**Historic Architectural Review Commission
Staff Report for Item 2**

Meeting Date: August 22, 2017

Application Number: H16-03-0033

Address: #724 Caroline Street

Color-coded 1948 Sanborn map.

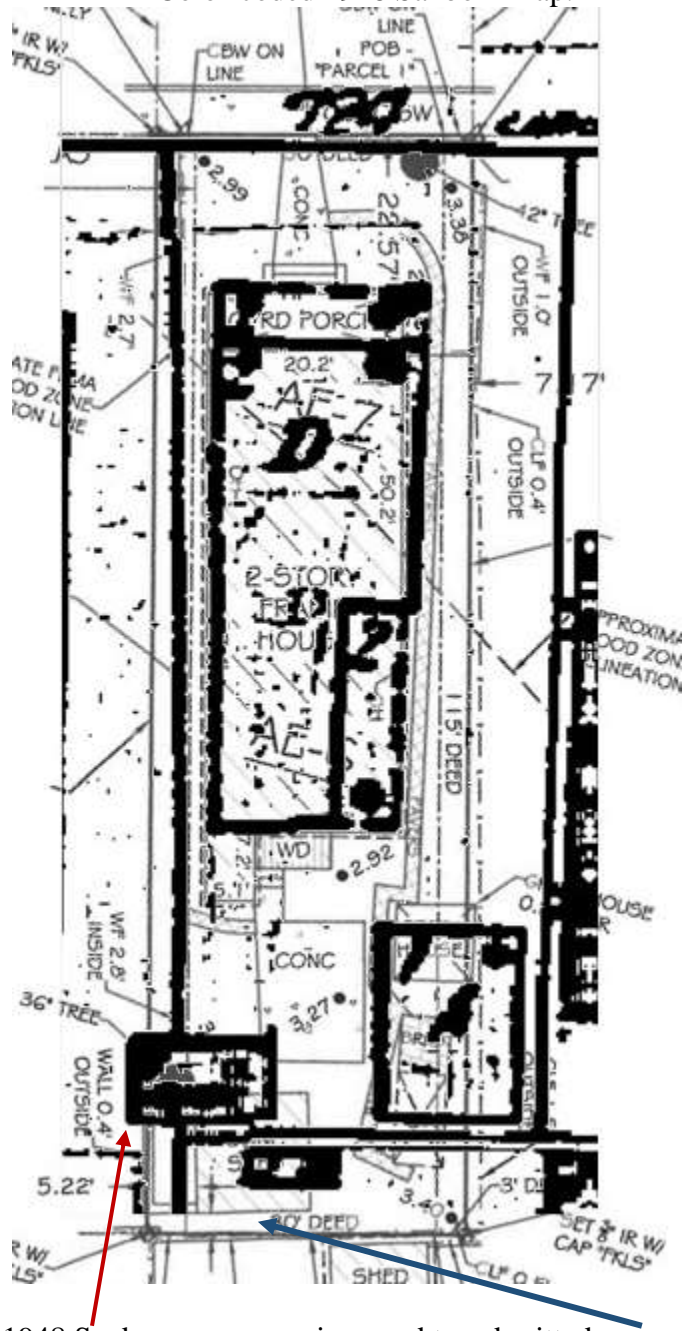
It is important to mention that staff has studied available information regarding the above ground cistern - “concrete shed” on the survey, that is proposed to be demolished. The Sanborn maps from 1899 through 1948, depict a cistern on the rear yard of the property. The 1948 color-coded Sanborn map depicts the cistern in blue color, which means that the structure is in concrete or masonry. The 1962 Sanborn map does not portrait any accessory structure on the site. The separation between the cistern and the historic rear footprint of the house in the Sanborn maps versus the location of the “concrete shed” in the survey are very similar. In addition, the construction materials are definitely more than 50 years old. It is evident that the height of the structure was altered through time and that the old mango tree roots have done some damage to the structure. For those reasons, staff will consider and review the request for this structure to be demolished as a historic resource.

The structure in question is not irrevocable compromised by extreme deterioration. There are some cracks due to the mango tree root system. The cistern has a wooden gable roof with metal v-crimp.

Staff opines that the structure has no distinctive characteristics of a type or method of construction. The structure was built for a utilitarian purpose and does not possess any architectural features. The structure has been altered through time.

The structure in question does not exemplify a remaining architectural type in its neighborhood and does not possess any significant visual features. There are still existing not altered historic aboveground cisterns that still preserve their original form and configuration, which can be considered as best remaining examples.

The structure in question may yield some information in history, but is not the best example of its kind.

In conclusion, it is staff's opinion that the Commission can consider the request for demolition proposed in the plans as it complies with the criteria for demolition stated under the Land Development Regulations. If approved this will be the last reading.
